Application for Licence Amendment

Licence Number	L9013/2016/1
Licence Holder	Gascoyne Resources Limited
ACN	139 522 900
File Number	DER2016/002214-1
Premises	Dalgaranga Gold Project Legal description – Mining Lease M59/749 and Miscellaneous Licence L59/151 DAGGAR HILLS WA 6638 As defined by the Premises maps attached to the Revised Licence
Date of Report	8 November 2021

Figure 1: TSF decant WAD-CN concentrations (mg/L)

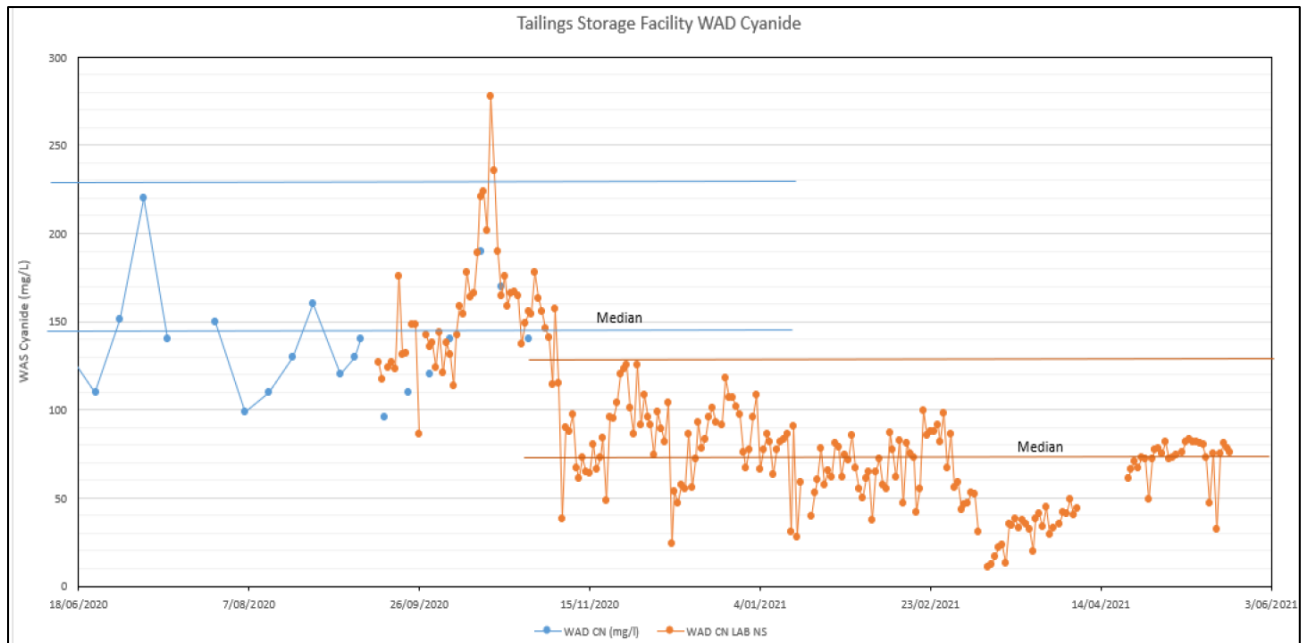
The Licence Holder is required to undertake monthly monitoring of the decant water and has done so since August 2018. Elevated WAD CN readings from the Gilbeys TSF decant water above the 50mg/L limit have been recorded throughout the last reporting period. Since January 2019, the WAD CN concentrations have ranged from below 50mg/L up to 200mg/L. Figure 1 below indicate the WAD CN concentrations of the Gilbeys TSF decant pond since April 2020.

The Licence Holder expects to continue to not comply with the 50mg/L WAD CN limit within the decant pond of Golden wings in-pit TSF as they expect they will continue to encounter ore with high levels of metal sulphides which will result in higher WAD CN concentrations within the decant pond. The Licence Holder therefore would like the WAD CN limit removed from condition 12 of the licence.

The Licence Holder wishes to have the limit (50mg/L) within condition 12 for WAD CN within the TSF decant ponds removed as they have been exceeding this limit for over 12 months. Monthly monitoring of the Gilbeys TSF decant water has been undertaken since August 2018.. The data indicates the pond is alkaline with pH readings between 8.4-10.3 and Total dissolved solids (TDS) ranging between 4,040mg/L – 9570 mg/L. Elevated WAD CN readings from the Gilbeys TSF decant water above the 50mg/L limit have been recorded throughout the last reporting period. Since January 2019, the WAD CN concentrations have ranged from below 50mg/L up to 200mg/L (see Figure 1).

Based on this risk assessment the Delegated Officer has determined that the removal of WAD CN limit from condition 12 (now condition 11) is acceptable. The Licence Holder will be required to undertake monitoring of bird visitation to the in-pit TSF decant pond, implement conventional bird deterrent technologies (gas guns and kites) and to undertake an investigation into the feasibility of the use of other conventional and modern bird deterrent technologies.
